Report: TAB REPORT
Function: Test, Adjust, & Balance
Date: 04/17/2024

PROJECT
04-08-24 CAVA MONTGOMERY, AL
(EASTCHASE)

Project: 04-08-24 CAVA MONTGOMERY, AL (EASTCHASE)

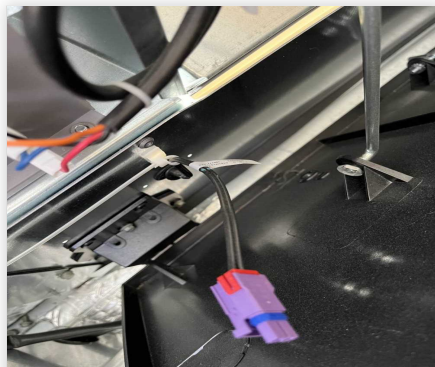
Issue Name : RTU1 & RTU3 / Enthalpy Sensor
Description : RTU1 & RTU3 enthalpy sensor is not operational. Recommend sensor be plugged in to the correct terminal.
Created By : National TAB **Assigned To :** National TAB - Brianna Biggs
Status : Open
Priority : High **Asset Tag :**
Originated Date : 04/15/2024 - Dale Wheeler - National TAB

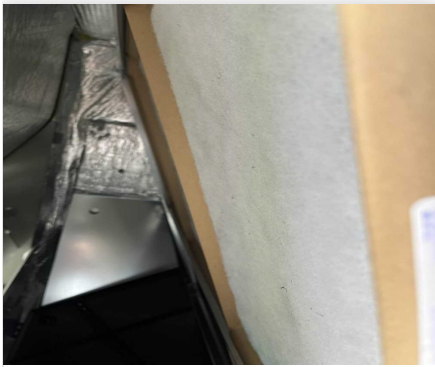
Issue Name : RTU1 / Missing Damper
Description : RTU1 SGRD7 damper is missing, unable to balance diffuser to within design CFM. Recommend having damper installed.
Created By : National TAB **Assigned To :** National TAB - David Annan
Status : Open
Priority : High **Asset Tag :**
Originated Date : 04/15/2024 - David Annan - National TAB

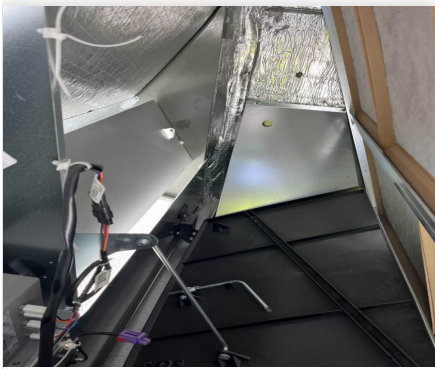
Issue Name : RTU1, RTU2, RTU3 / Construction Filters
Description : RTU1, RTU2, RTU3 construction filters are installed. Merv 8 pleated filters should be installed on all units.
Created By : National TAB **Assigned To :** National TAB - Brianna Biggs
Status : Open
Priority : Medium **Asset Tag :**
Originated Date : 04/15/2024 - Dale Wheeler - National TAB

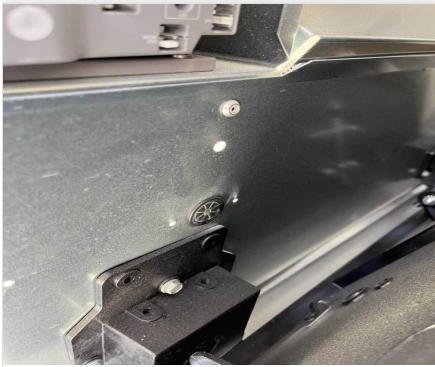
Issue Name : RTU1, RTU2, RTU3 / Economizers
Description : RTU1, RTU2, RTU3 economizers do not close when thermostats are placed into unoccupied mode.
Created By : National TAB **Assigned To :** National TAB - Brianna Biggs
Status : Open
Priority : High **Asset Tag :**
Originated Date : 04/16/2024 - Dale Wheeler - National TAB
